**STS-109  
FLIGHT READINESS REVIEW**

**FEBRUARY 14, 2002**

**Orbiter**

# WCS CHECK VALVE FAILURE

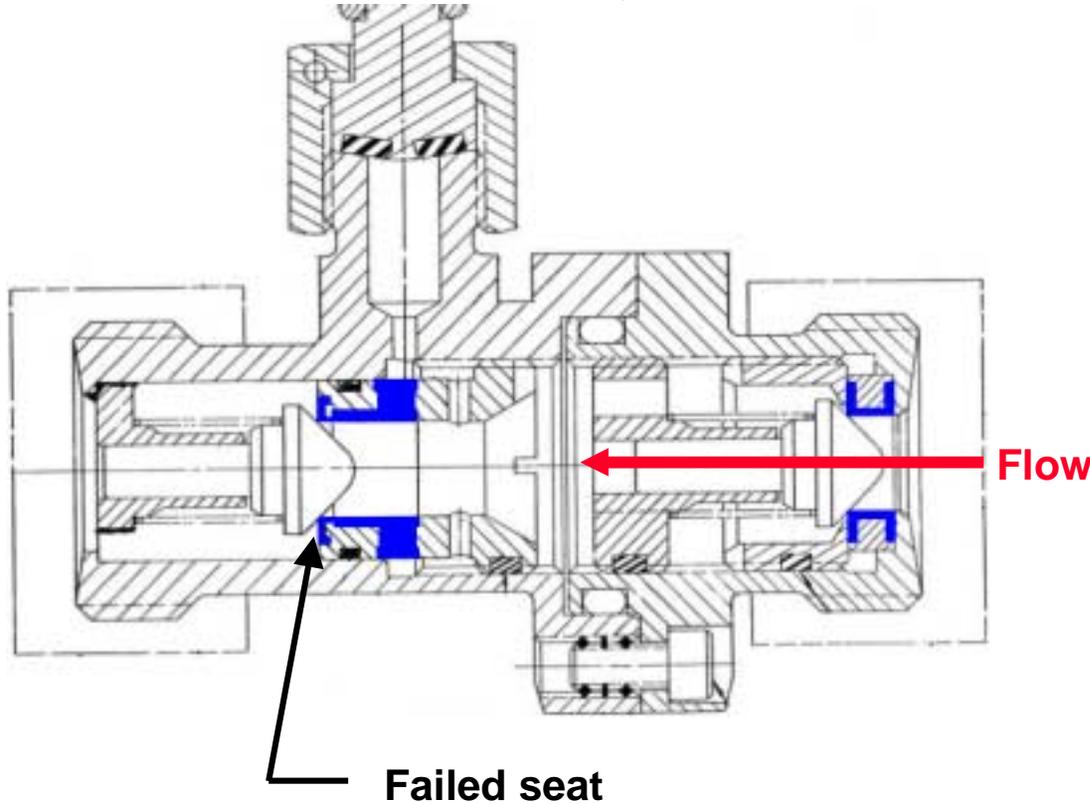
- **Observation:**
  - During turn around processing, a WCS fan separator check valve (S/N 021) failed bubble leak check test
    - Flown on STS-98 and STS-105 in primary fan separator
    - Used for entire mission on both flights with no problems
- **Concern:**
  - Failure of both check valves could allow waste water to leak into the crew compartment
- **Discussion:**
  - Check valve was disassembled and inspected
  - Approximately 90% of the seat material was missing, and it is believed to never have been there
  - No evidence of residual material in areas where material is required
  - Material found was smooth; no appearance of cuts, tears, etc.

Missing  
Seat  
Material

- Suspect check valve has passed sensitive bubble leak check
  - More sensitive than liquid leak check
- Multiple failures required before impact to mission operations
  - Crew procedures exist to deal with multiple failure effects

# STS-108 POST-LANDING DRAG CHUTE DAMAGE OBSERVED

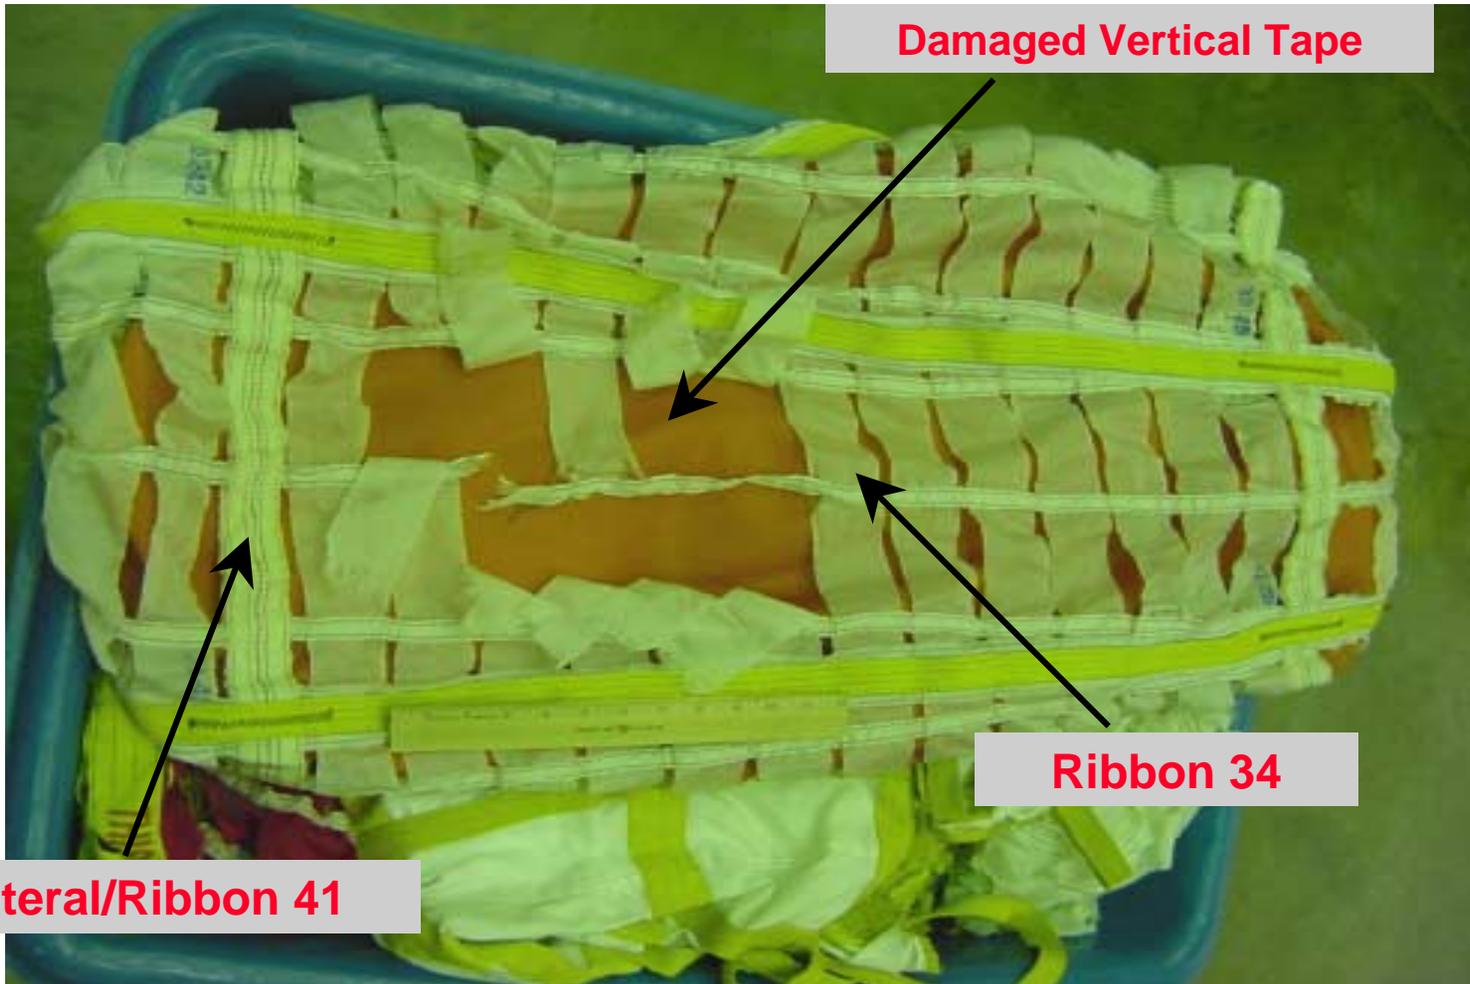
- STS-108 rollout videos show damage to the drag chute canopy
  - Hole appears shortly after deploy from bag
  - Parachute Refurbishment Facility (PRF) found ribbons 34 through 40 and one vertical tape on gore 31 damaged

- Damage/holes in drag chute canopy may produce uneven drag forces during rollout

- First ever incidence of damage to seven, 300-lb nylon ribbons in one location
  - Typical repair on a refurbished parachute shows one damaged ribbon at one or two locations
- Damaged vertical tape material is 90 lb strength double ply nylon tape

- Drag parachute system is crit 3/3
- Lateral “rip stop” reinforcements prevent holes from becoming too large
- Very small loss (~0.2%) in drag chute deceleration does not adversely affect drag chute performance
  - No reported problems from pilot which indicate any impact on vehicle control
  - Stopping distance and brake energies nominal

### Observation #2: Pilot Chute Deployment Bag Damage

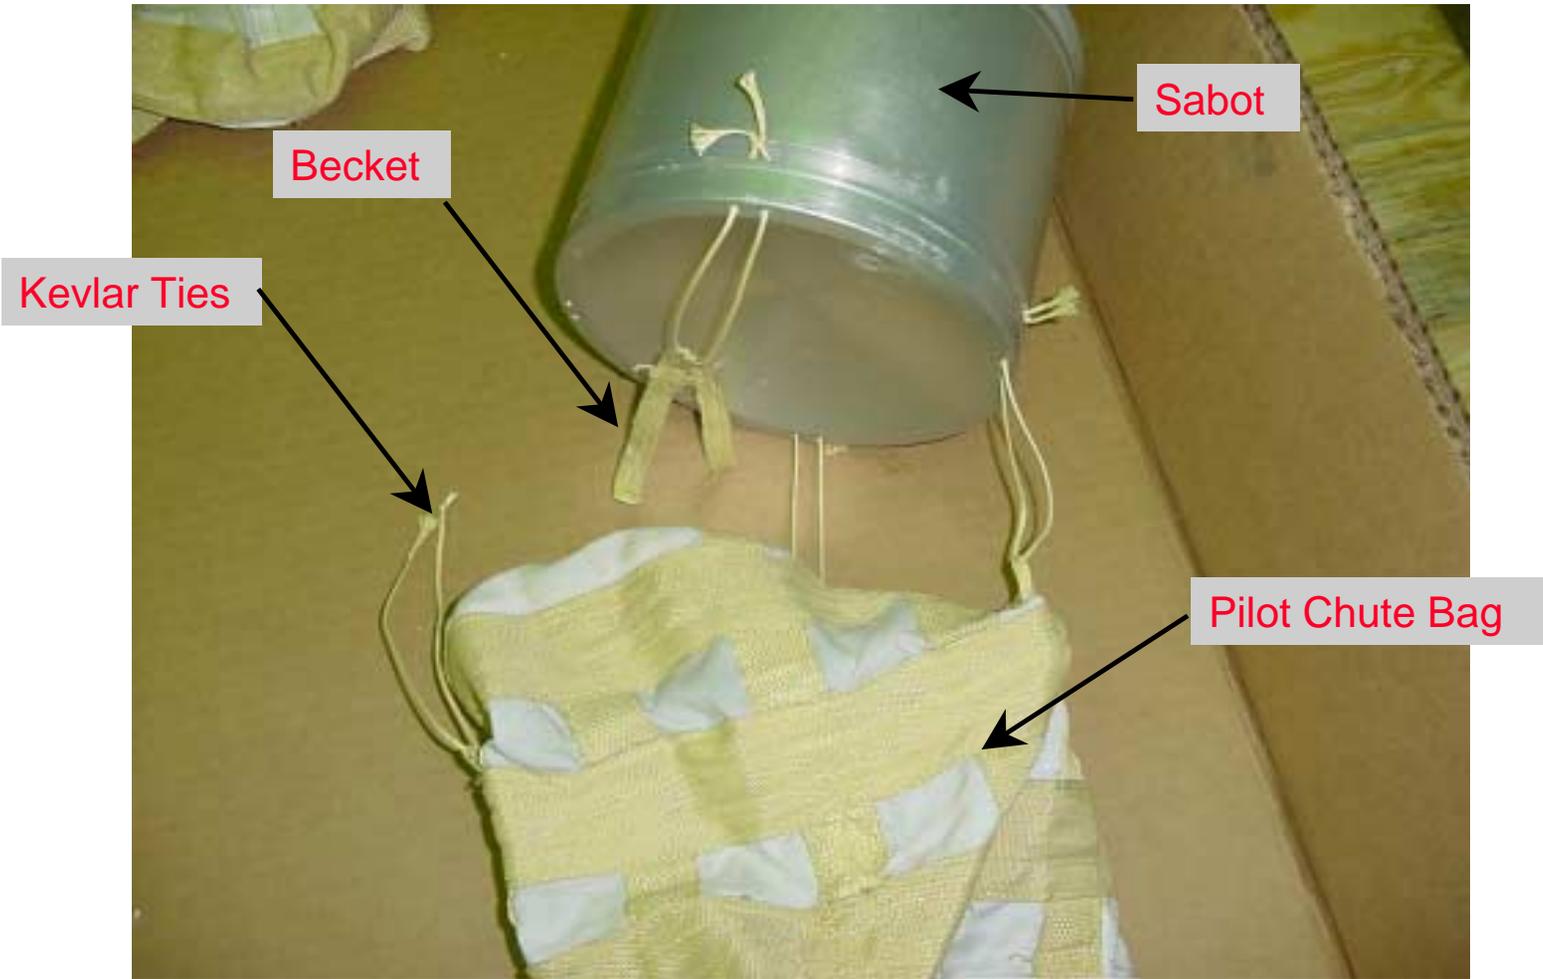
- A review of STS-108 drag parachute hardware at PRF identified one of four Kevlar ties that secure the pilot parachute deployment bag to the sabot was loose/untied
  - One of the three remaining deployment bag beackets/loops had completely torn loose from the bag while the two remaining loops have broken stitching
  - Kevlar ties on remaining three beackets/loop attachments to the sabot were intact
  - Remaining knots in loose tie showed evidence of loading prior to/during knot failure

- Loose ties holding sabot to deployment bag may result in improper pilot chute bag separation and subsequent failure of main chute to deploy

- Drag parachute system is crit 3/3
- Loss of attachment redundancy did not affect system operation
  - Remaining Kevlar attachments continued to pull pilot chute bag off of pilot chute
- Off-nominal testing has proven that even when the sabot completely separates from the pilot chute bag, the pilot chute still fully deploys (JSC-26536)

Kevlar Tie (1 of 4)

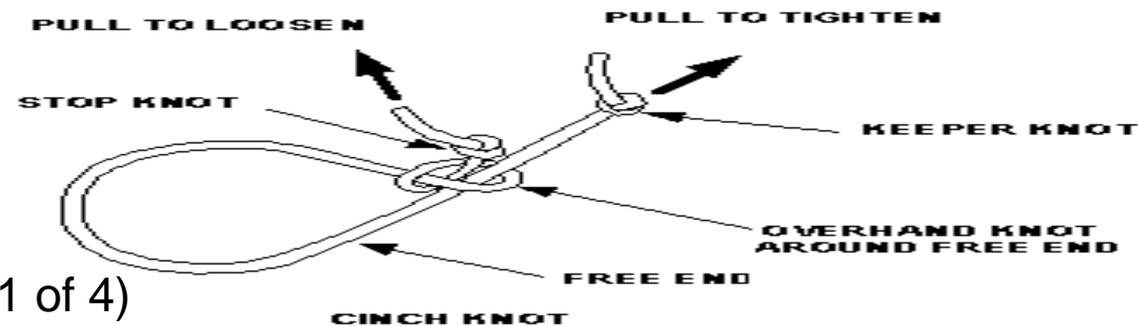
- Fault tree developed to identify all possible failure modes
- Most probable cause of the failed line is loss of or a missing stop knot and loosening of the cinch knot allowing the keeper knot to slip through the cinch knot
  - Inspection may have overlooked stop knot since all knots combine into single point
  - Opportunity exists for looseness in knots to occur during insertion or compression of sabot and bag into mortar tube
- First failure of tie likely caused subsequent failure of one bucket/loop on deployment bag

Cupped washer

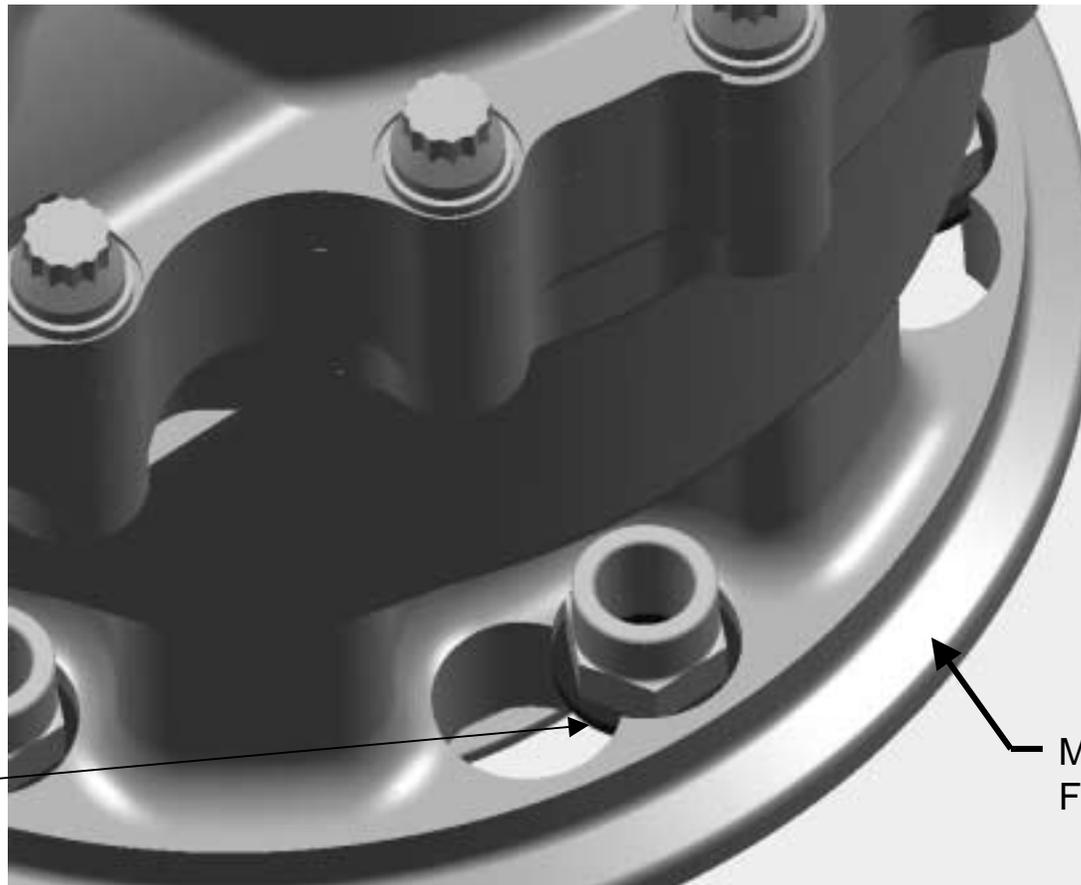
- Inspection of removed washers from the OV-102 position 3 hydraulic pump-to-APU mounting studs revealed that they were cupped

- Over time, cupped/bent washers may relax and result in loss of preload

- A design change was made (April 2000) to increase the outside diameter of the washer from  $.640 \pm .010$  to  $.710 \pm .002$  to increase the load distribution area
  - Coining damage to pump mounting flanges had been observed from the smaller diameter washer
  - Larger washers have flown on OV-104 (3 flights) and OV-105 (1 flight)

Aluminum pump mounting flange is designed with slots to facilitate installation with nuts installed on APU studs

- Stress analysis indicates sufficient margin of safety with bent washers
  - OV-102 pumps have not experienced flight loads
- No history of failure of the APU/pump joint
- Pump operation is verified pre-launch (APU hot-fire)
- Redundant capability exists
  - Hydraulic system is criticality 1R/2

<b>HYDRAULIC MAIN PUMP PORT CAP BOLTS</b>	<b>Presenter:</b> D. White
	<b>Organization/Date:</b> Orbiter/02-14-02

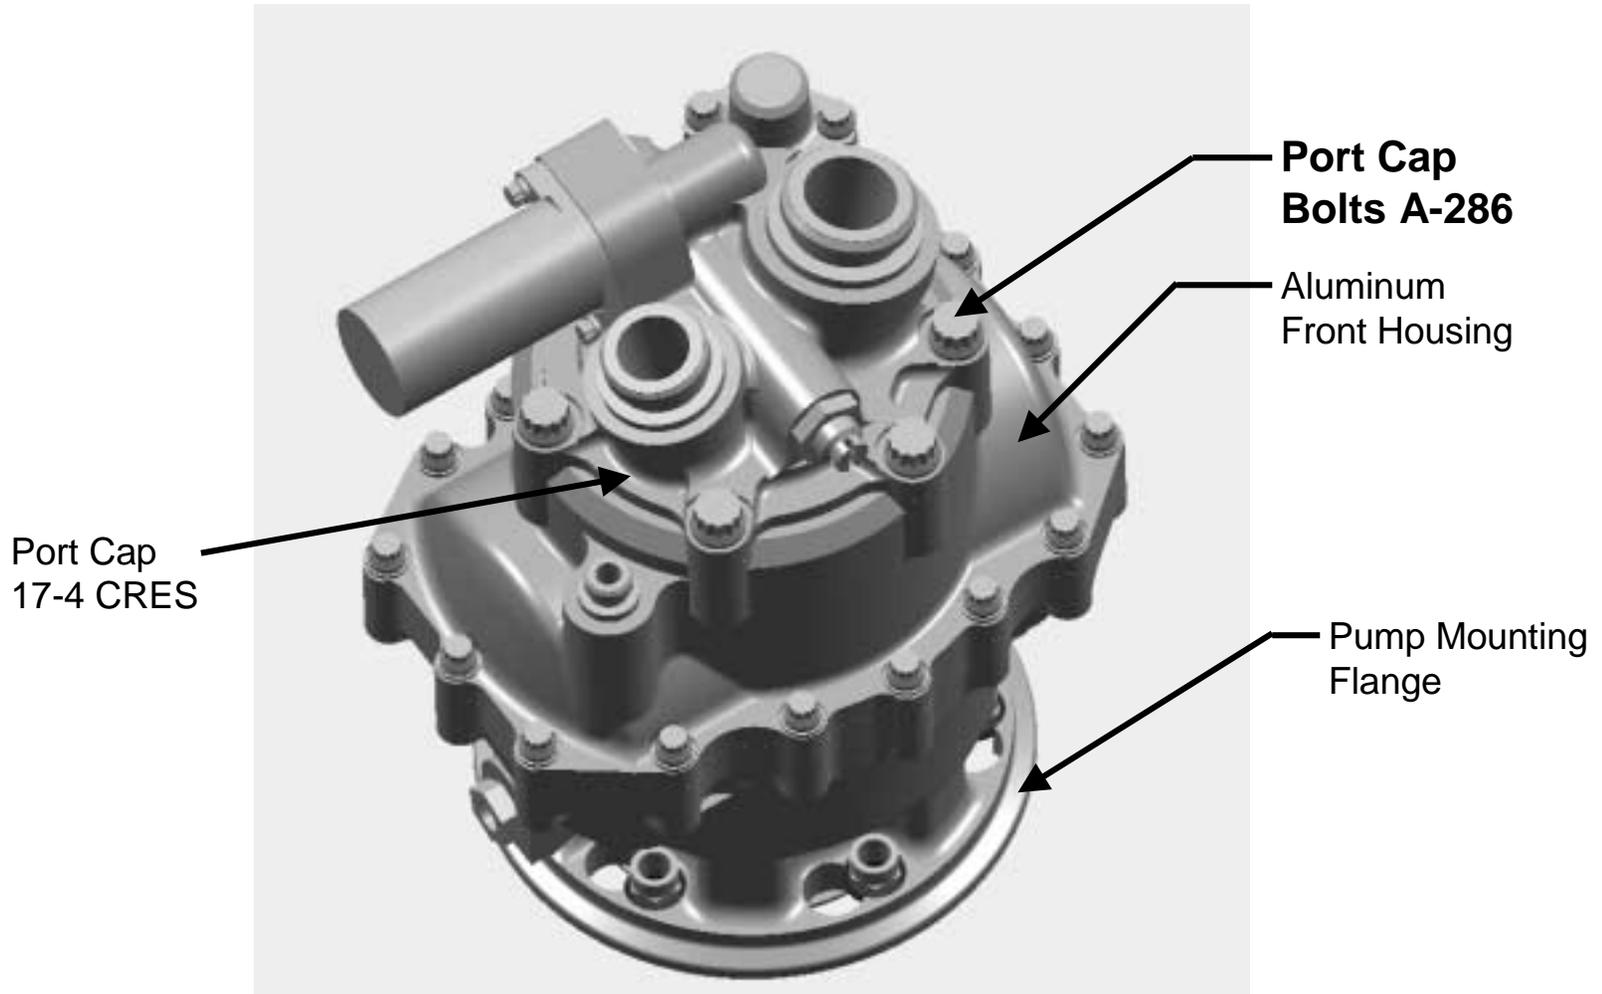
- Bolts at the port cap / front housing interface on the OV-102 hydraulic pumps are dry film lubricated (DFL); should be passivated
  - Inspection of OV-102 pumps revealed all 6 bolts on all three pumps are DFL

- Possible insert pull-out due to higher preload resulting from lower coefficient of friction for the DFL bolts
  - Potential hydraulic pump port cap separation and hydraulic fluid leak, resulting in loss of hydraulic system (criticality 1R2)

- Discussion on values for shear area and coefficient of friction is continuing
  - Technical community meeting in Huntington Beach to finalize values

**Port cap / front housing interface utilizes dry film lubricated threaded key locked inserts**

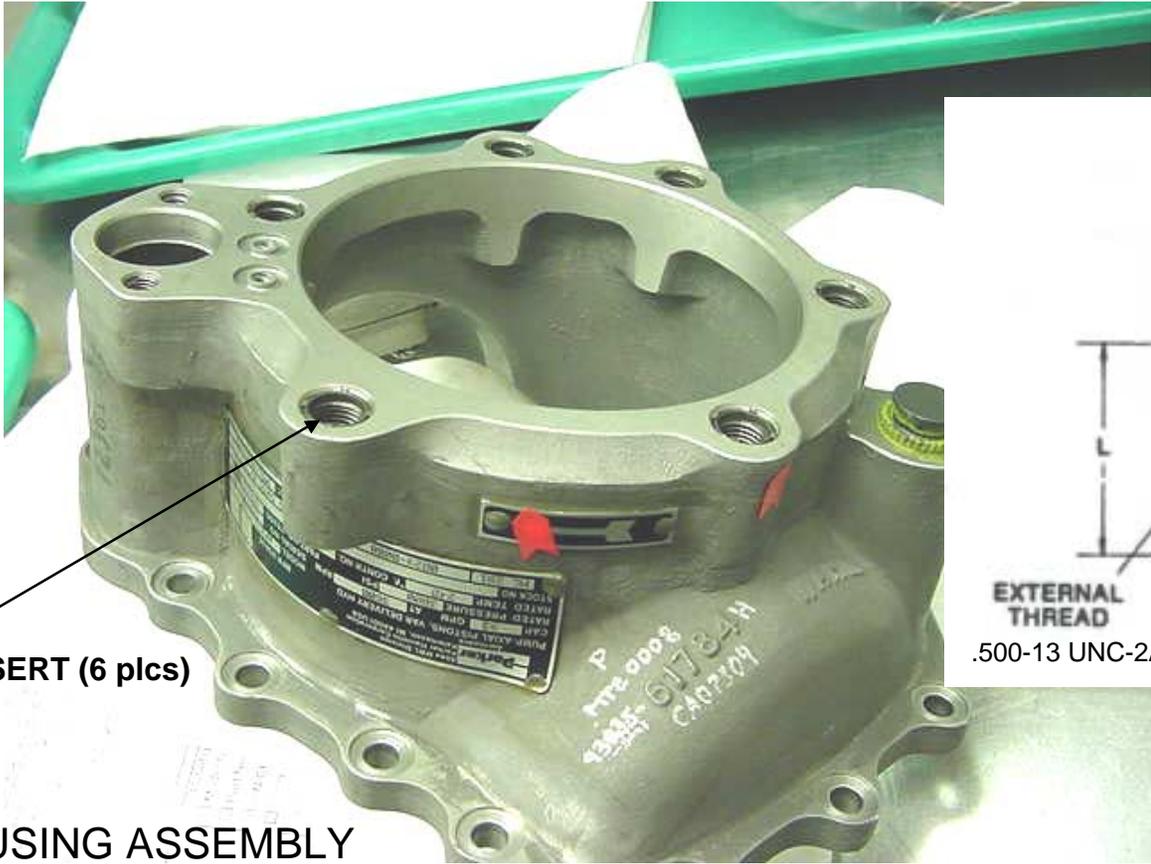
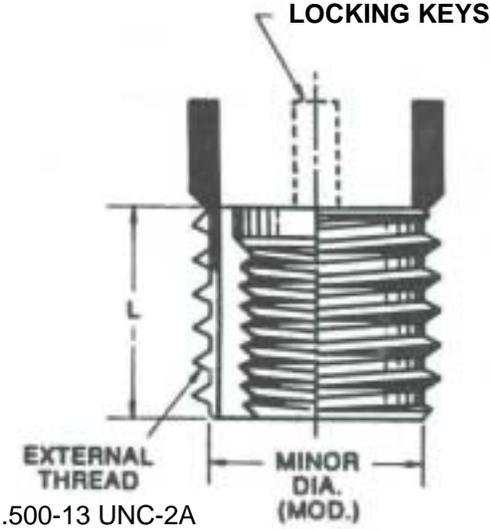
- During drawing review for a port cap/check valve modification, it was noted that the supplier drawing called out DFL bolts (P/N RD111-4009-6606) on the port cap versus passivated bolts (P/N RD111-4009-0606)
  - Pump was certified in 1975 utilizing passivated bolts
  - Supplier made drawing change to DFL bolts approximately 1975 to 1977 without program approval
  - Recent update to the pump procurement specification to identify the bolt part numbers allowed detection of this discrepancy
- Both bolts are A-286
  - Original bolt is passivated per MIL-S-5002
  - DFL bolt is entirely coated with moly-disulfide dry film lubricant

Figure 1

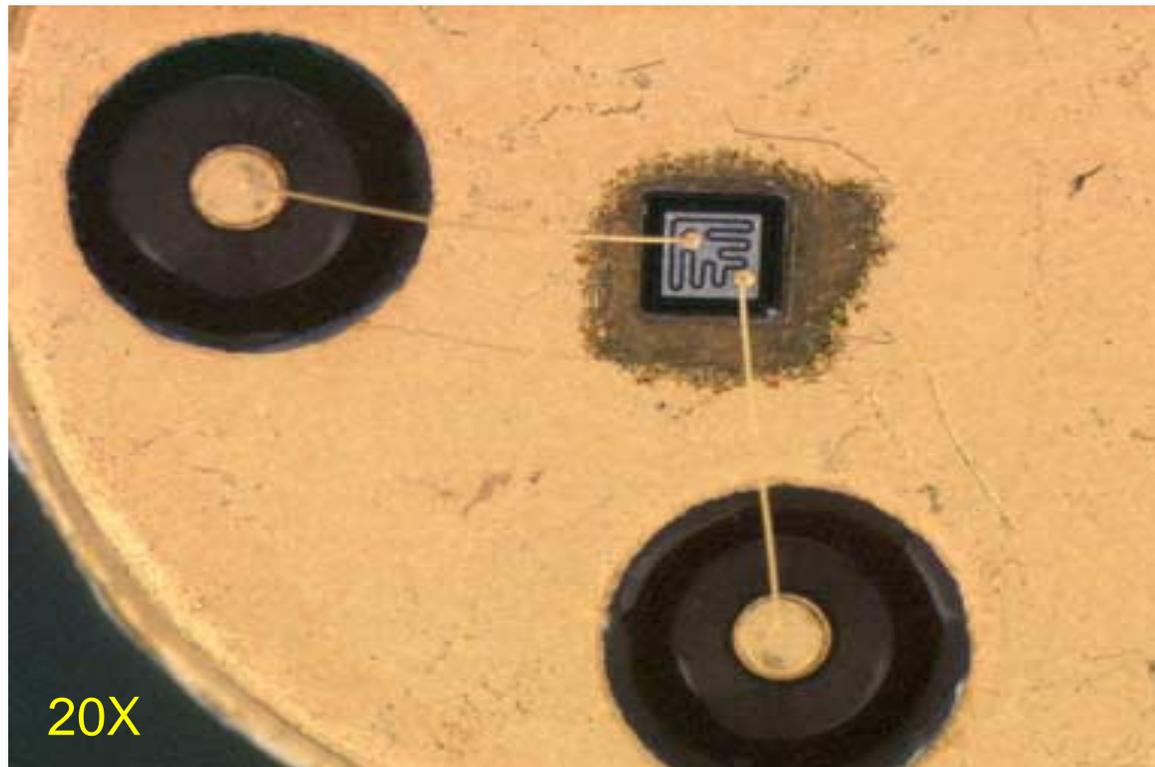
- The DSC CVRD module Q503 transistor failures (detached base and emitter bond wires) are illustrated in Figures 1 through 4

### Bond Wires Appear to be Attached to Die

Figure 2

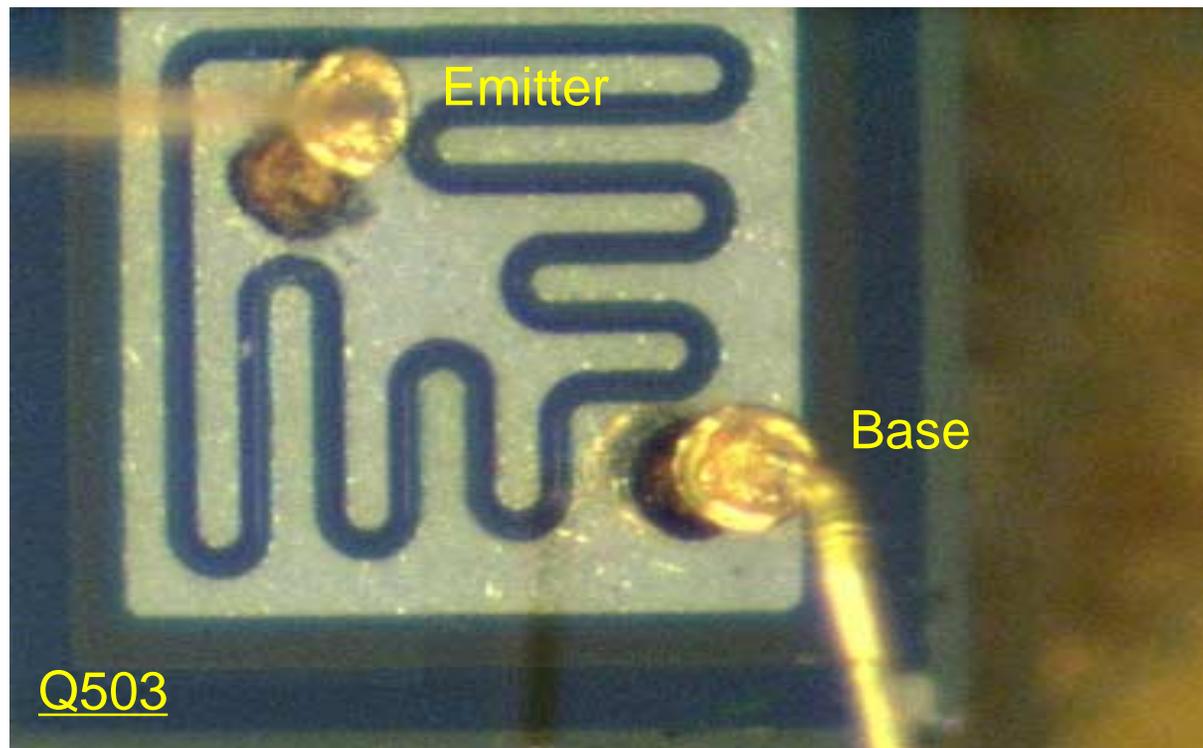
Closer Examination Shows Bond Wires Are Actually Detached
